Powerhouse Precinct Parramatta

Powerhouse SSDA report – Security
CPTED Assessment - Addendum

PHM-ARP-REP-SC-0005

Issue 05 | 8 October 2020

Figure 2 Powerhouse Museum Precinct Entrances

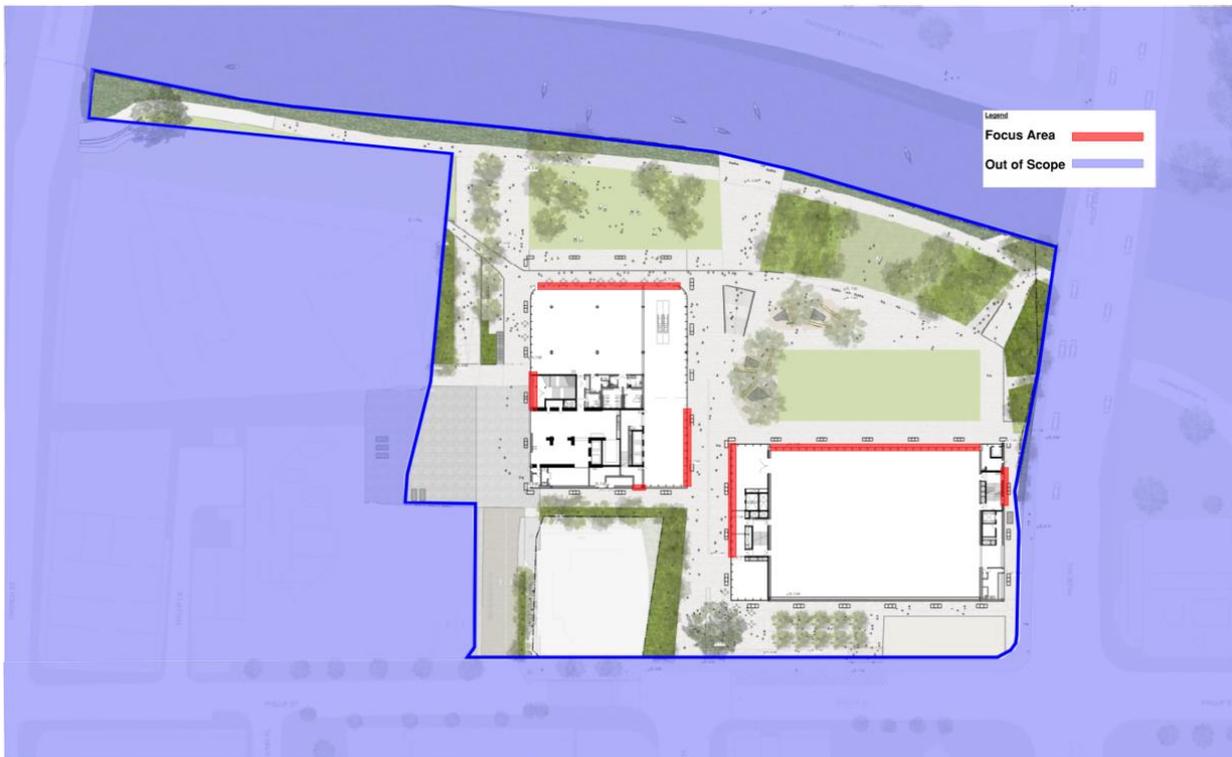
Multiple building entrances have been noted throughout the precinct (see Figure 2). As a result of the potential for higher foot traffic in these locations during operational hours, relatively high natural surveillance is expected. It is anticipated that this will reduce outside of operational hours where the precinct is less populated and may present opportunities for carrying out criminal behaviours with lower likelihood of detection. Crime threat scenarios for building entrances may include: crimes against the person such as assault and theft from the person. It also is noted that there is the potential for property crimes including break and enter and general theft offences.

- Provide clear sightlines from pathways to entrances;
- Facilitate clear sight lines from within the building such that users can see the space prior to exiting;
- Clearly distinguish the entrance from public walkways through:
 - Changes of material and texture in the pavement;
 - Level changes, and;
 - Signage – to indicate public entrances/ restricted access entrances as well as direct patrons leaving the facility toward key transport/ exits (e.g. buses, taxis etc.)
- Design the entrance to limit opportunities for potential threat actors to hide.

Figure 3 Undercroft access points (River Level)

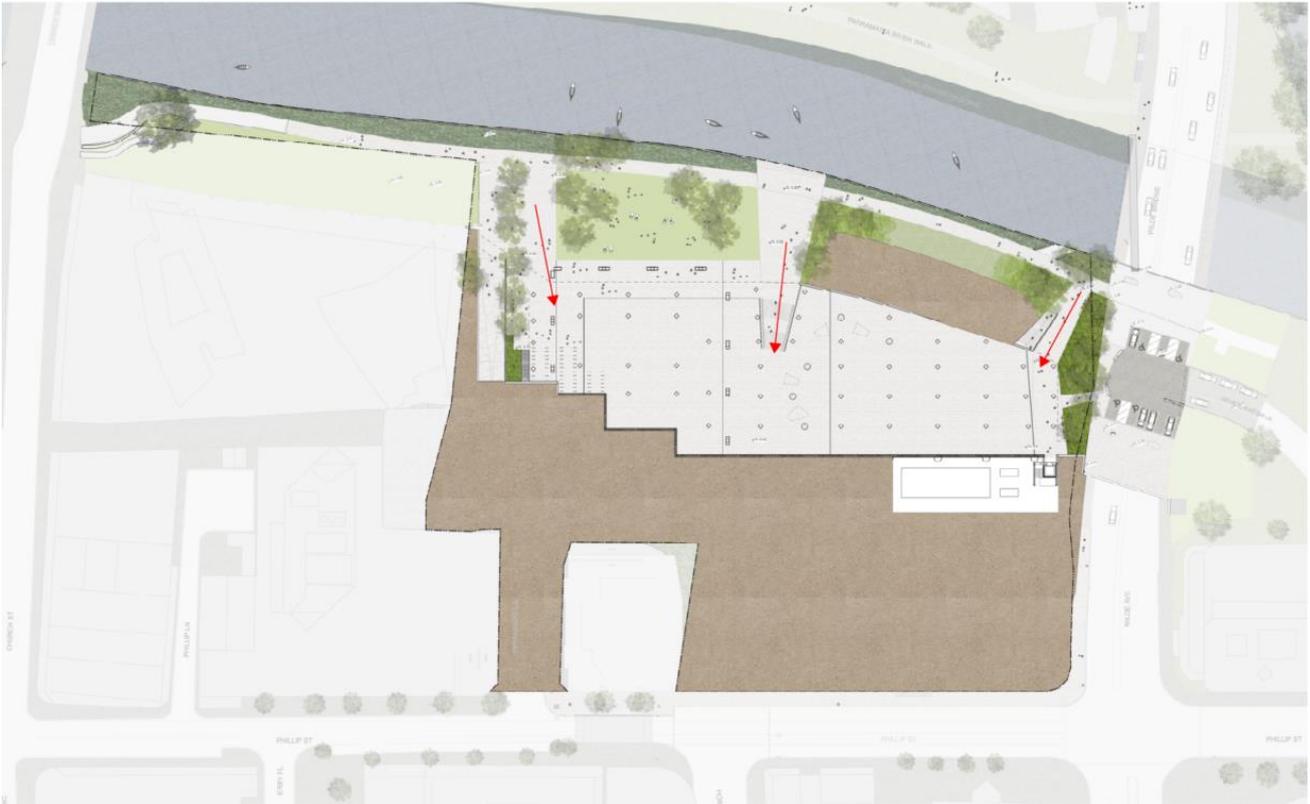
The undercroft is shown on the plan with pedestrian access from multiple points. Structural elements of an undercroft mean it is a large open (but undercover) space with reduced sightlines from structural columns, similar to underground parking structures. The undercroft is accessible from three ends beneath the Podium (see Figure 3), with visual surveillance from the building or lawns above obscured by the Podium. This limits passive surveillance specifically to other users of the undercroft during operational hours and may present opportunities for criminal or antisocial behaviour with this reduced likelihood of detection.

- Comprehensive CCTV coverage;
- Adequate lighting
- Operational plans for presence during managed events with security patrols and CCTV monitoring by 24-hour onsite security; and
- Clear wayfinding signage that indicates pathways for patrons.

However, the area will only be accessible to the public for managed events by Powerhouse. At all other times the area will be closed to the public through the use of screens.

The screens will only be open for managed events where staff will be in attendance. In addition, 24 hour on-site security and CCTV will assist with management of the space. The only other time that the undercroft screens will be opened is in the event of a flood, where there will be no people allowed within the space.

Figure 4 Architectural Plans showing the undercroft location, with adjacent bicycle storage facility

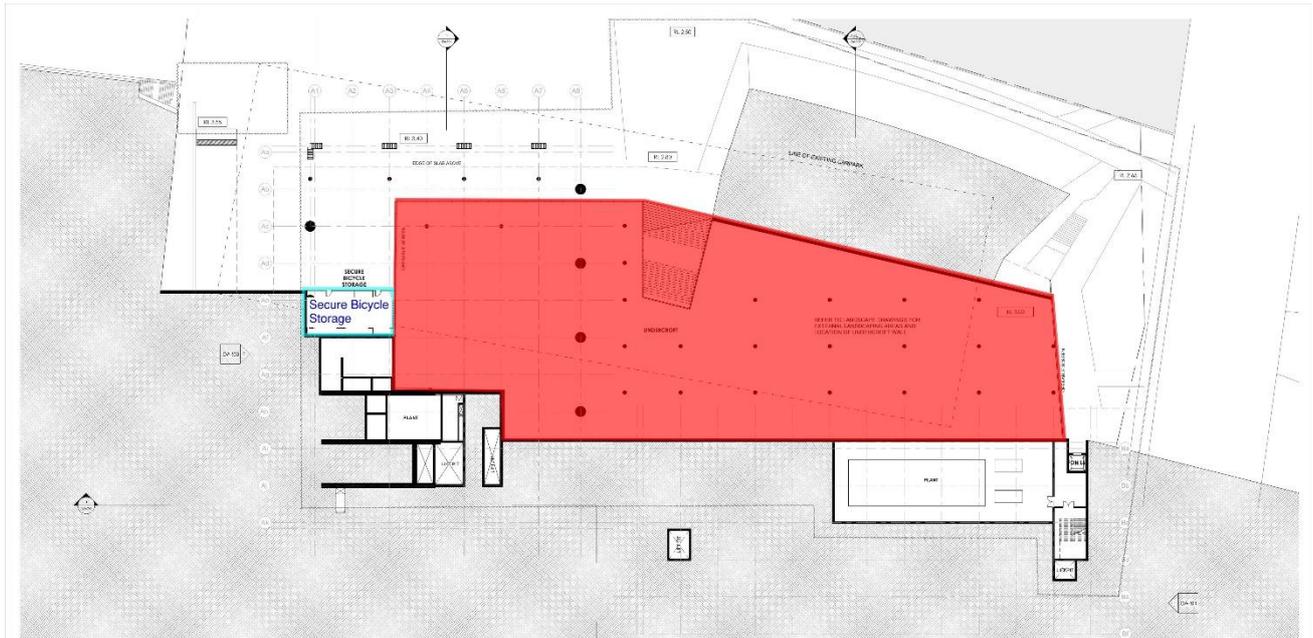
Crime threat scenarios for the undercroft may include: crimes against the person such as assault and theft, property crimes including break and enter, graffiti/vandalism and motor vehicle or bicycle theft. It is also noted that adjacent to this undercroft is a secure bicycle facility which may attract criminal activity such as theft or property damage. This facility is shown in Figure 4.

Figure 6 Powerhouse Museum Precinct Seating Areas

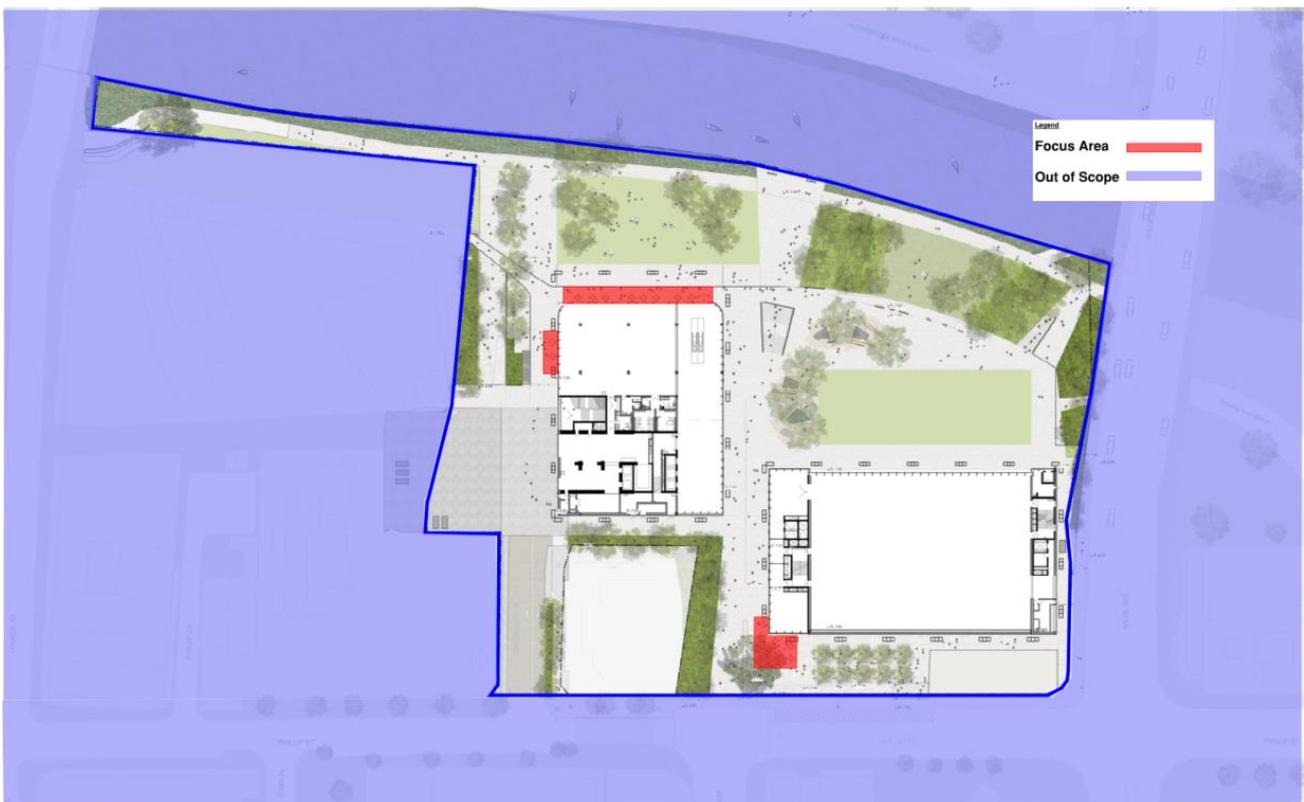
The amended landscape design has two additional seating areas compared to the design lodged with the EIS. Despite these additional seating areas, the impacts of CPTED remain consistent.

- Implementing regular maintenance schemes in line with the site-wide recommendations to repair/restore furniture that is damaged.
- Designing lighting to enable pedestrians seated in the area to identify potential security hazards around them;
- Vandal resistant materials and finishes should be considered for furniture. Additionally, removable furniture can be considered for usage while complying with the proposed strategies.
- Implement signage/ changes to pavement material/ texture to direct patrons to safe pathways.

Figure 8 Powerhouse Museum Precinct Coach Stop

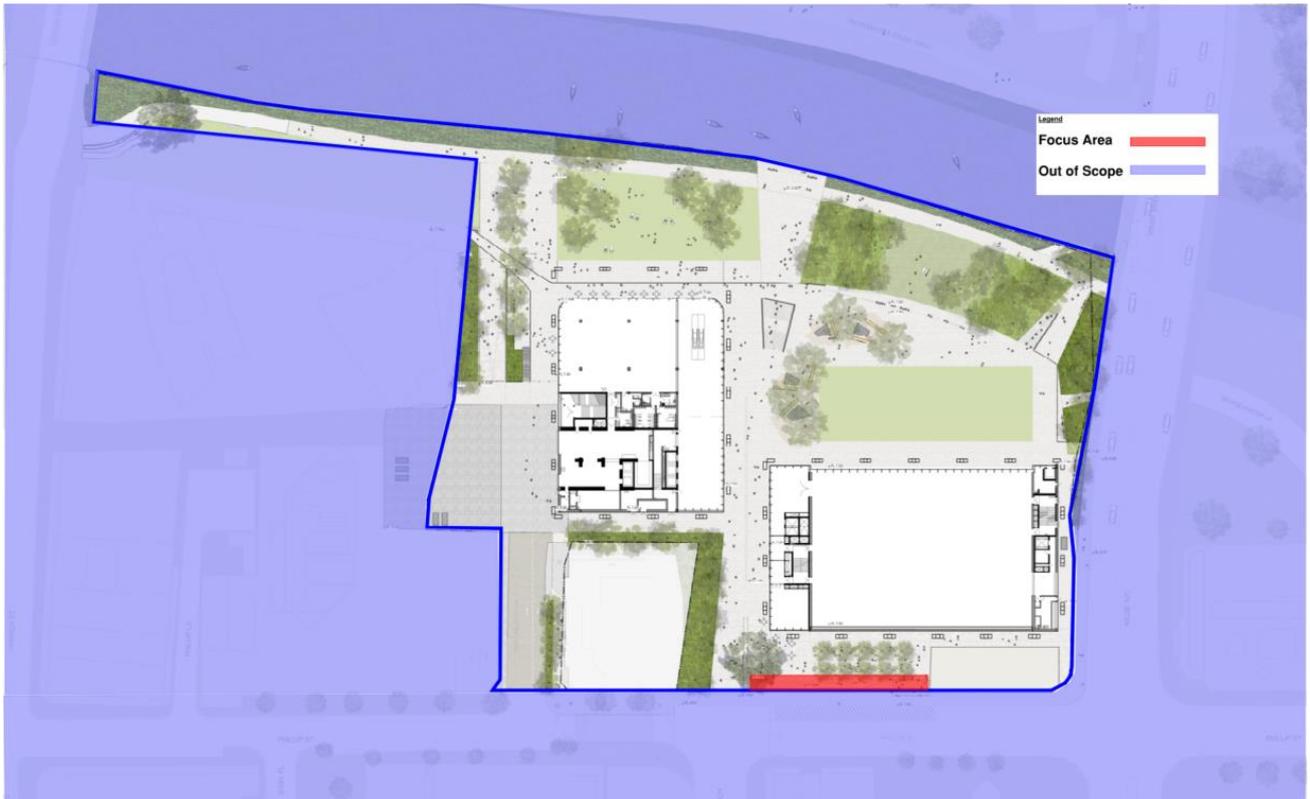
A coach stop area is shown on the current plan that has been relocated to Phillip Street rather than an indented bay as per the design lodged with the EIS (see Figure 8). Despite the design change, the recommendations provided for CPTED remain consistent.

- Minimise potential hiding opportunities by facilitating clear passive surveillance of the bus stop from the footpath and roadway. Consider impact on visibility of assets such as the terraces, rubbish bins, bus shelters and landscaping;
- Where possible, sightlines are to be maximised from the nearby terraces to enable visibility of surrounding areas, e.g. removing vegetation that may obstruct sightlines;
- Implement lighting and maintenance strategies consistent with the site wide guidelines, particularly in the surrounding space involving the terraces;
- Vandal resistant materials and finishes should be considered for any bus stop assets (e.g. shelters, signage) that are proposed.
